UNITED STATES PATENT AND TRADEMARK OFFICE

| APPLICATION NO. | FILING DATE | FIRST NAMED INVENTOR | ATTORNEY DOCKET NO. | CONFIRMATION NO. |
|---|-------------|----------------------|---------------------|------------------|
| 10/776,851 | 02/11/2004 | Uwe Jurgen Becker | CM2687MQ | 3886 |

| Office Action Summary | Application No. 10/776,851 | Applicant(s) BECKER ET AL. | |

DETAILED ACTION

FIG. 6

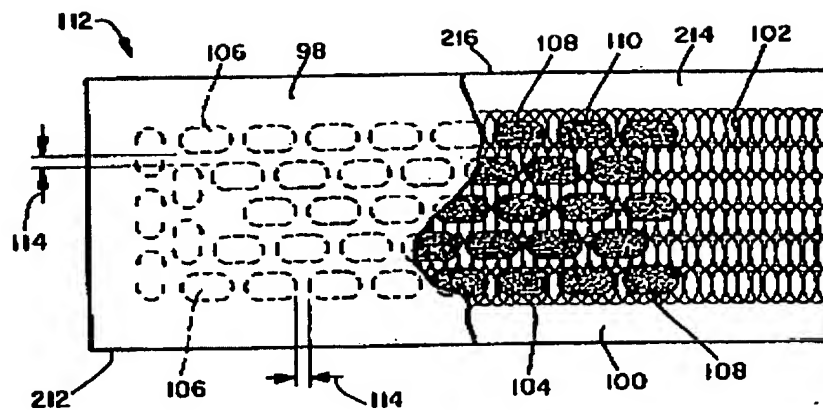
Regarding claim 1, Tanzer *et al.* teach an absorbent core (112, 120) useful for an absorbent article comprising a substrate layer (98) and absorbent material (110), said absorbent material (110) comprising an absorbent polymer material and *optionally* an absorbent fibrous material, said absorbent fibrous material not representing more than about 20 % of the weight of absorbent polymer material, wherein said absorbent material (110) is immobilized (trapped in pocket regions (108)) when wet such that said absorbent core (112, 120) achieves a wet immobilization of more than about 50% according to the Wet Immobilization Test (see figures 6 and 7, below).
